# Technical Bulletin

HAMMOND ORGAN

January 14, 1966

26 E-100 Series  
E-200 Series  
E-300 Series

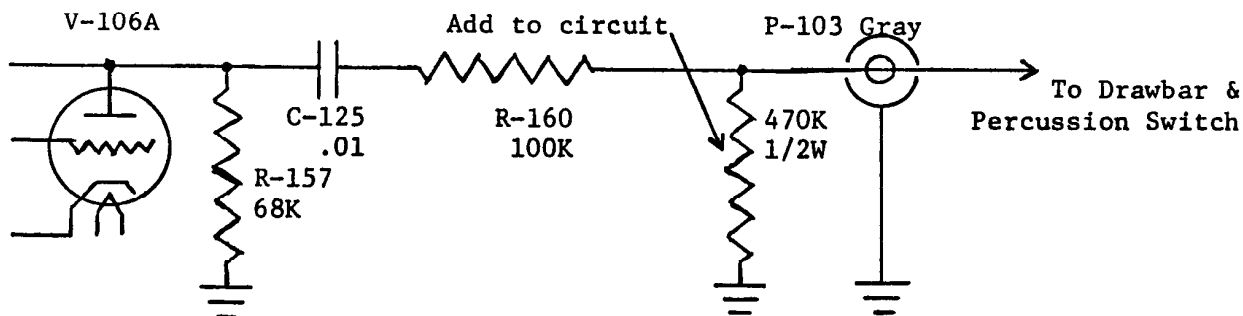
To eliminate Percussion pop when "Drawbars and Percussion" tab is depressed. Add A470K 1/2 watt resistor in Percussion amp. chassis as indicated in drawing below.
